**Government of India
Ministry of Railways
Research, Designs & Standards Organisation
Manak Nagar, Lucknow - 226 011**

MODIFICATION SHEET NO. RDSO/WAM4/151

**SAFETY VALVE OPERATED SIGNALLING AND OIL DUCT
SYSTEM OF TAP CHANGER TYPE NO. 32 HBB MAKE**

RDSO. ELEC. DTE. SK.EL: 3885

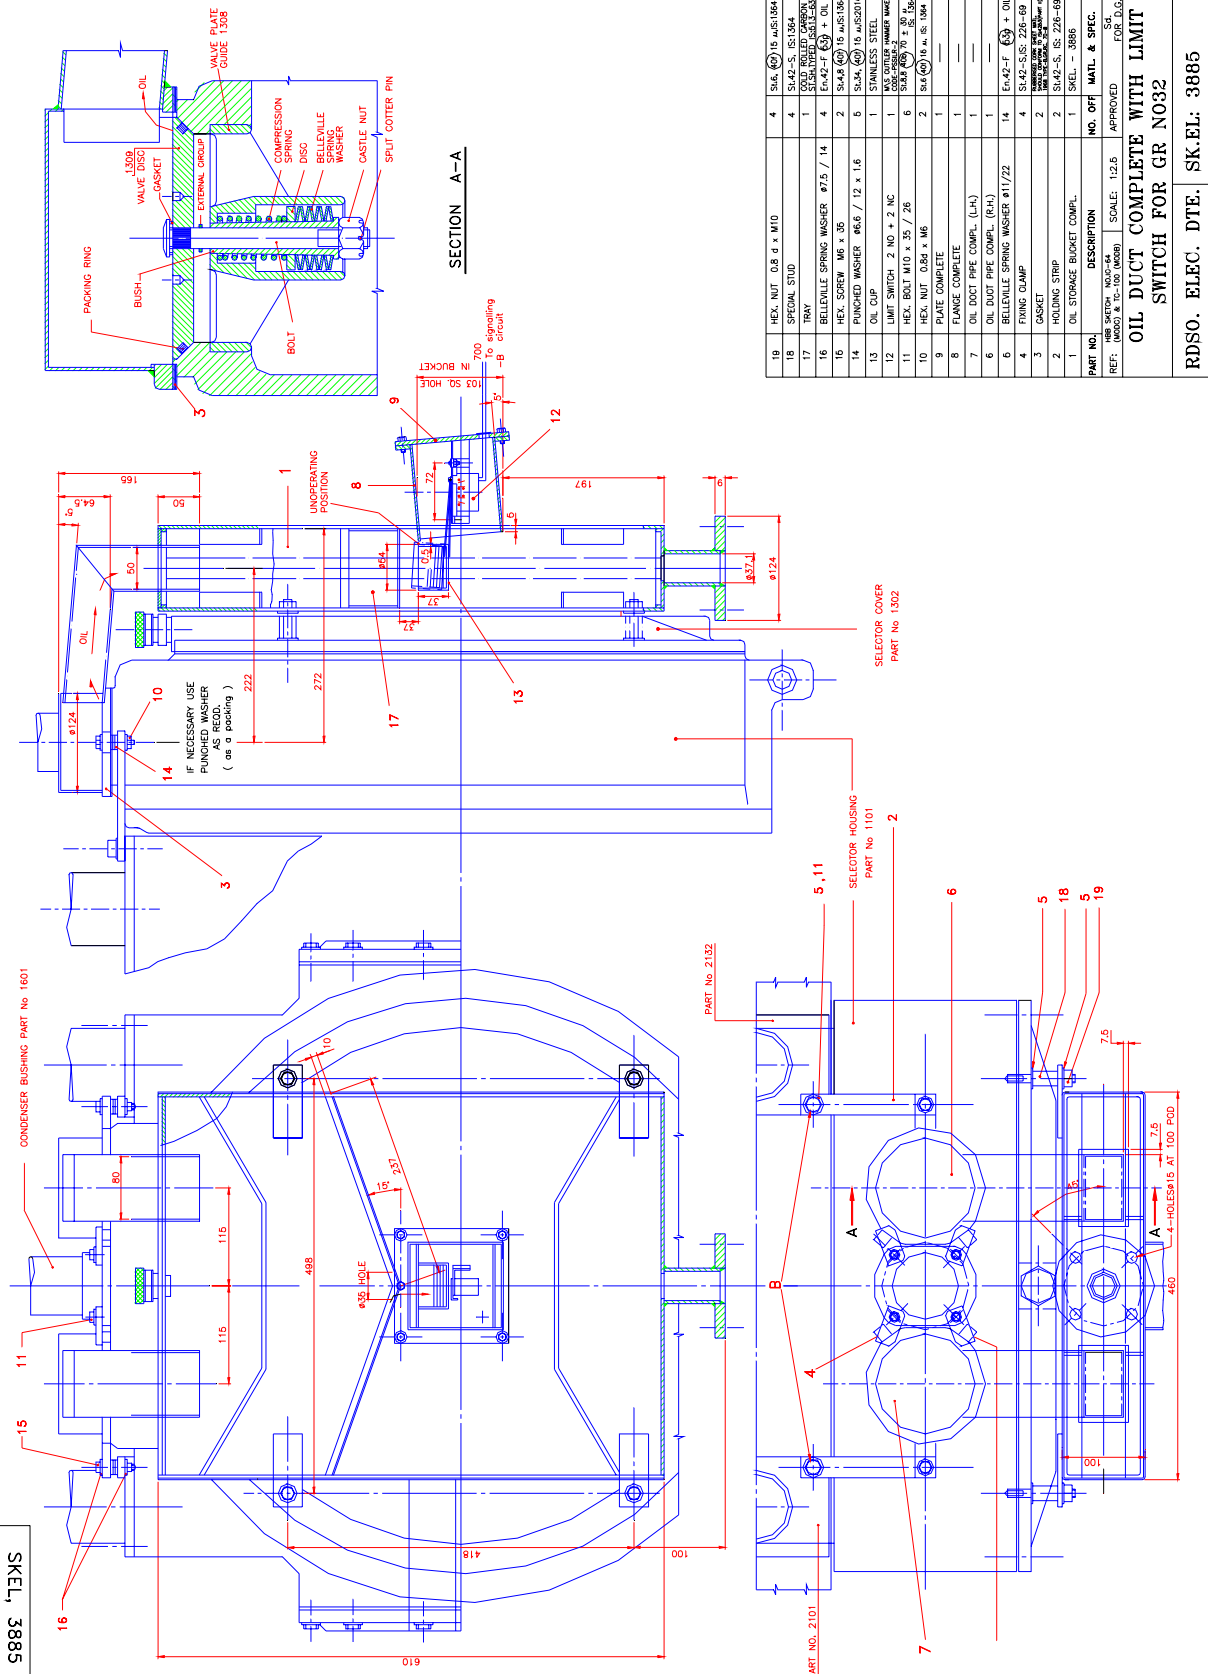
In modification Sheet No. RDSO/WAM4/91 dt. 5.2.80, it was proposed to provide ducting over the safety valves of the tap changer to prevent splashing of the oil inside the loco in the event of safety valve operation. It is further proposed to provide a limit switch in ducting arrangement to operate lamp and buzzer in both the cabs to give signal of blowing the safety valve to the driver, so that the driver may not operate tap changer after blowing of the safety valve. Minor improvements in the above for easy fitment of ducting & limit switch arrangement modification have also been incorporated as per drawing No.s SK EL 3885 & 3886. Limit switch is operatable by splashed oil.

Modify the existing ducting arrangement/fabricate new as per drawing No. SK EL 3885 & 3886 . Take a limit switch type 2 NO + 2 NC, Code - PS SIIR-Z of M/s Cuttler Hammer alongwith the lever. Keep the length of lever 110 mm from the centre of the operating part of the switch by cutting extra length. Cut upto slot level, the Coller of base of lever and remove sharp edges and burs as shown in enclosed drawings. Stainless steel cup of the outer dia 54 mm, height 37 mm thickness 0.3 to 0.5 mm is to be spot welded with switch lever. Provide the modified limit switch in the duct as shown. In normal condition the limit switch contact should remain open. Schematic wiring diagram of limit switch, lamp and buzzer is shown in SK EL 3886.

- (ii) Open the selector cover part No. 1302.
- (iii) Loosen the 4 Nos.. bolts (Pt 11) M10 x 25 and replace them with M 10 x 35/26 bolts Hex bolt alongwith fixing clamp (Pt. 4)
- (iv) Replace the 2 bolts at the portion indicated at "B" with M 10 x 36/25 bolts after assembling holding strip (Pt. 2)

- (v) After keeping gasket (Pt. 3) in position place the oil duct pipe complete in the respective position. Ensure that the fixing clamps (Pt. 4) rest on flange of oil duct pipe complete. Keep the Hex. screw (Pt. 15) in position alongwith punched washer (Pt. 14) and Belleville spring washer (Pt. 16)

- (vi) Ensure the valve disc (1309) moves freely inside the oil ducting by pushing the disc upwards by hand from inside the selector before tightening the bolts (Pt.) of fixing clamp (Pt. 14) . If necessary, use punched washers (Pt. 14) as a packing while tightening the hex. (Pt. 10) of hex. screw (Pt. 15) to ensure proper alignment.

- (vii) After tightening again ensure the free movement of guide disc inside the ducting when operated by hand. The force required to operate the valve disc 10 \pm 2 Kg.

- (viii) Refit the selector cover, assemble the special stud (Pt. 18) and mount the oil storage bucket (Pt. 1) with limit switch (Pt. 12).
 - (ix) Connect drain pipe at the bottom of the oil storage bucket as shown in the drawings.

- (x) Ensure that the oil cup of limit switch is not touching the oil guide of oil storage bucket and the limit switch is in the 'normally open' condition.

- (xi) Provide indication lamp and buzzer in each cab and connect them with existing loco battery of 110 VDC through limit switch as per drawing.
 - (xii) The collection of oil in oil cup due to splashing will cause the limit switch to close and the connected bulb and buzzer will be operated.
